REMARKS

The drawings were objected to as allegedly failing to comply with 37 CFR 1.84(p)(5) for including reference signs not mentioned in the description. These objections are addressed in the following:

FIG. 3

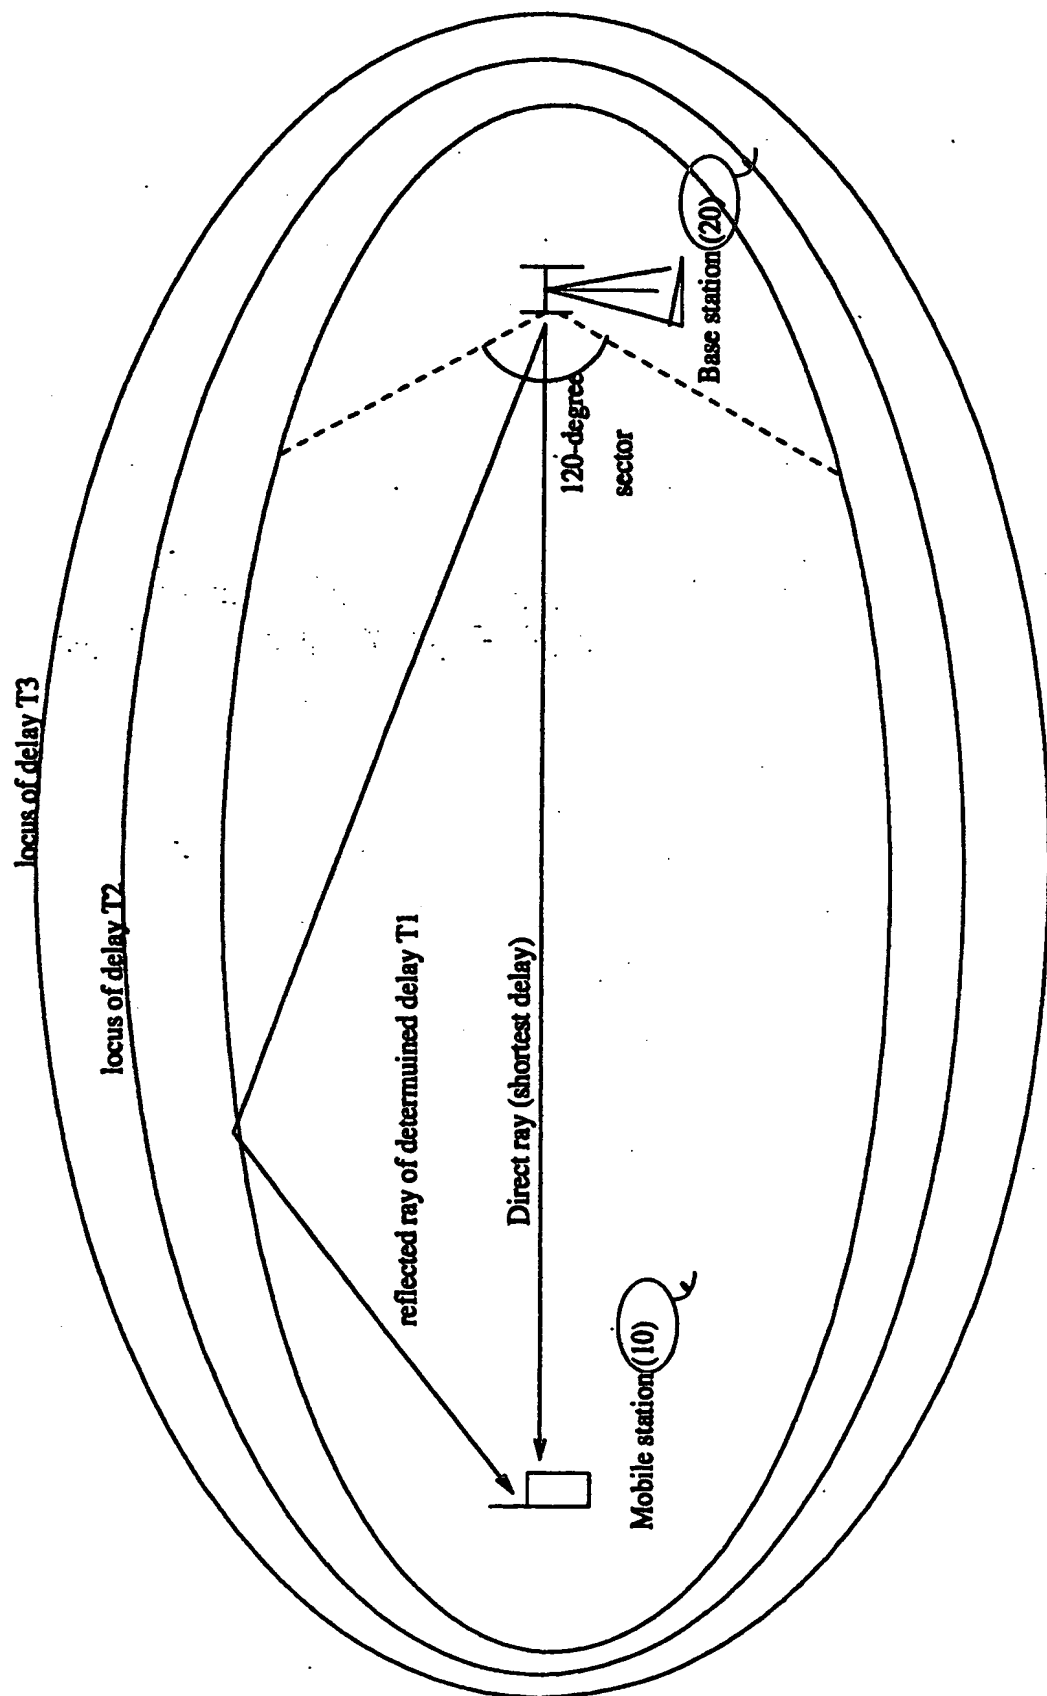
Regarding Fig. 3, the Office objected that reference numerals 10 and 20 are not mentioned in the description. In response, Fig. 3 is now amended to remove reference numerals 10 and 20.

FIG. 6

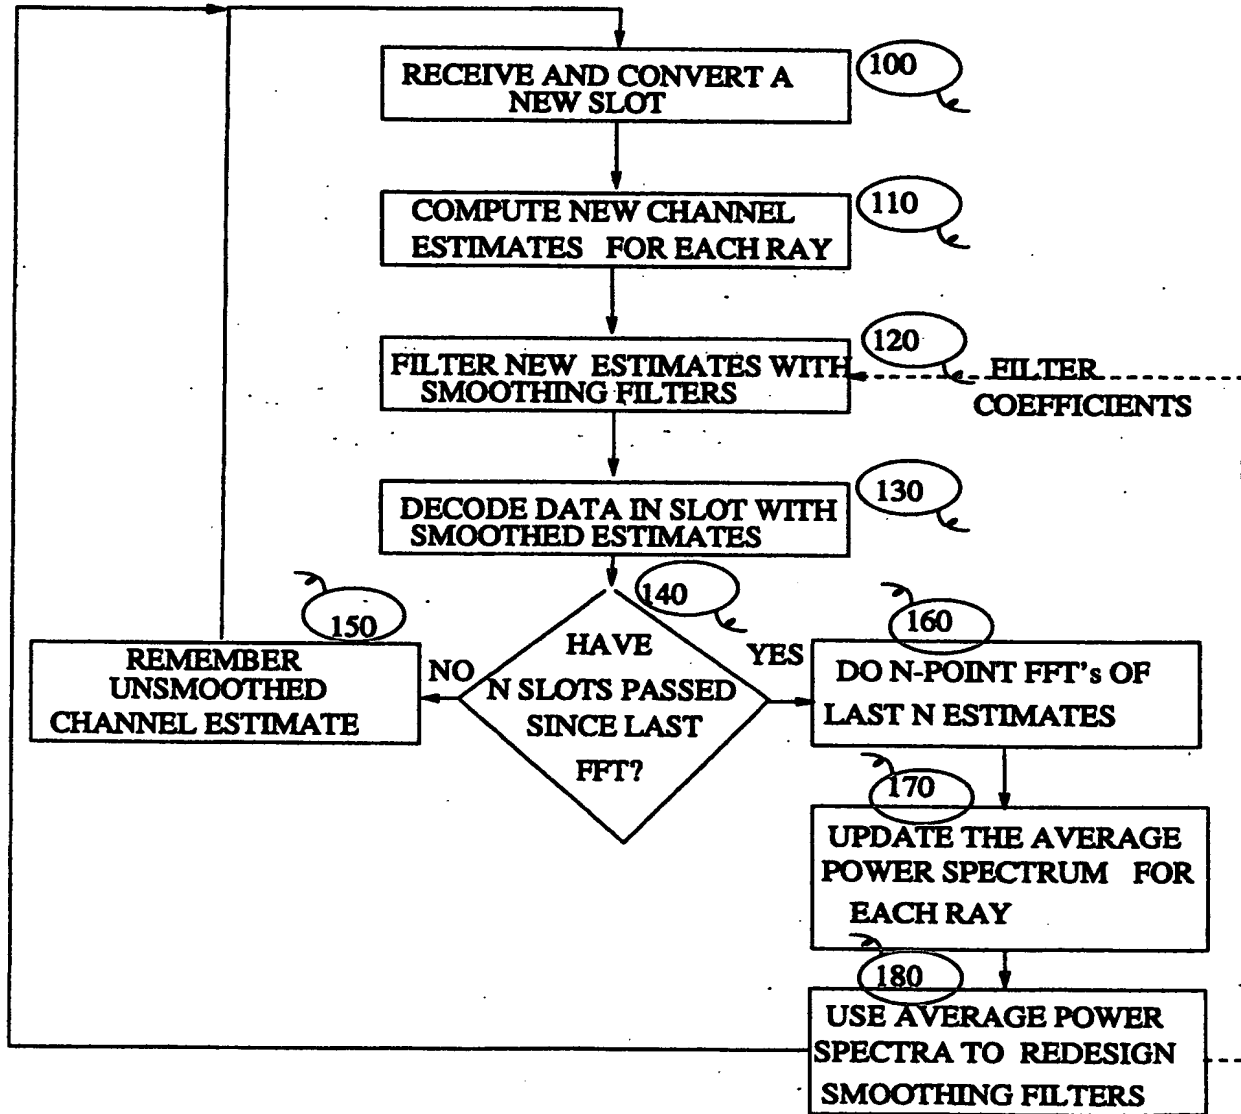
Regarding Fig. 6, the Office objected that reference numerals 100, 110, 120, 130, 140, 150, 160, 170, and 180 are not mentioned in the description. In response, Fig. 6 is now amended to remove these reference numerals.

FIG-10

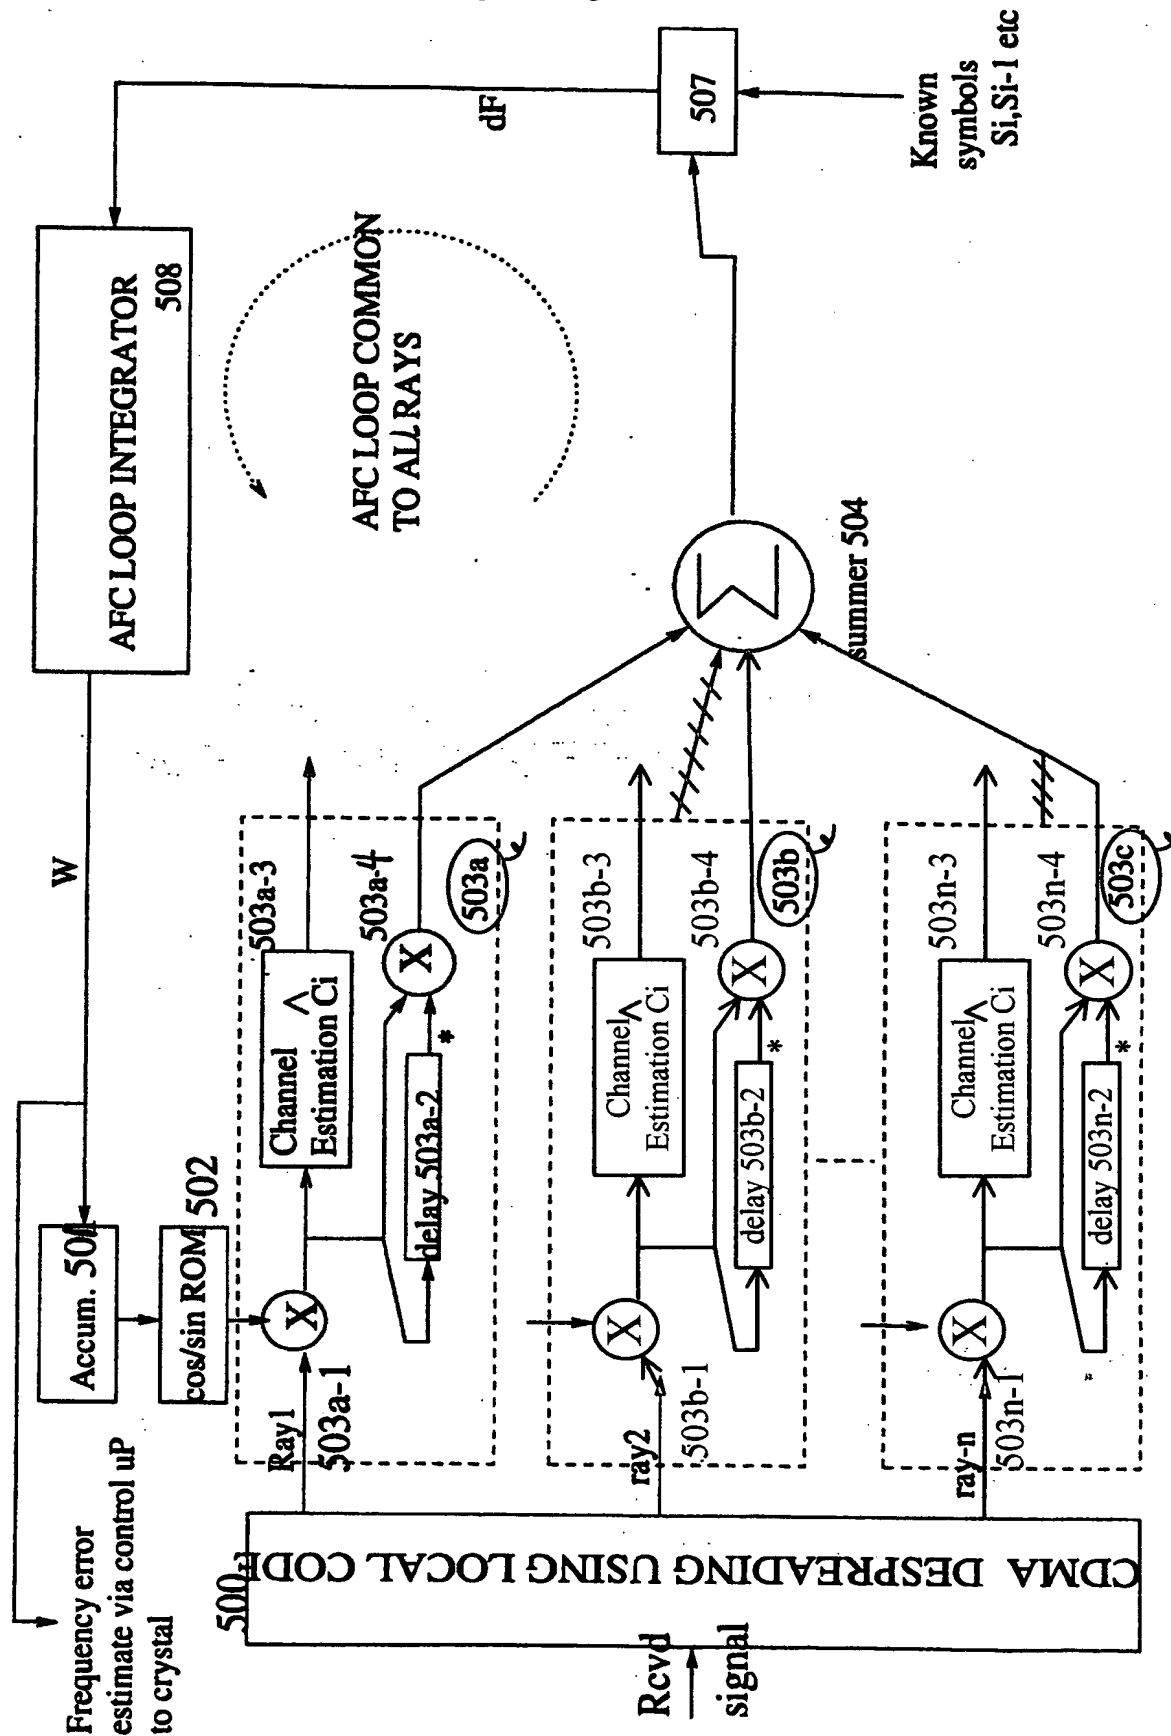
Regarding Fig. 10, the Office objected that reference numerals 503a, 503b, and 503c are not mentioned in the description. In response, Fig. 5 has been amended to remove these reference numerals.

The drawings were further objected to for allegedly not including the following reference signs mentioned in the description: reference characters 503b-1 – 503b-4, 503n-2 – 503n-4 in Fig. 10, and reference character 508-1 in Fig. 15A.

In response, Fig. 10 has been amended, without introduction of new matter, to expressly include the elements referred to by reference characters 503b-1 – 503b-4, 503n-2 – 503n-4, and of course to include these reference characters themselves.
